E5091A-03

S E R V I C E N O T E

Agilent E5091A Multiport Test Set

SW2 Coaxial Switch part number change

Opt. 009

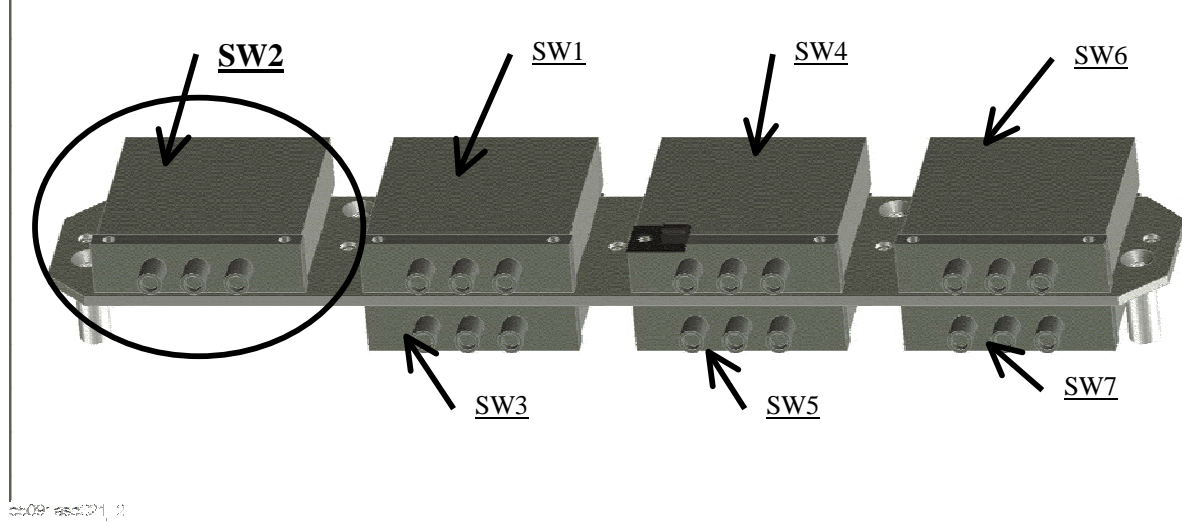
The coaxial switch that is used for SW2 of the E5091A was changed from 5087-7137 to 5087-7272 to improve an input voltage tolerance. Switches parts were used as follows:

Use a newer part 5087-7272 when replacing SW2. Refer to following figures about the SW2 position.
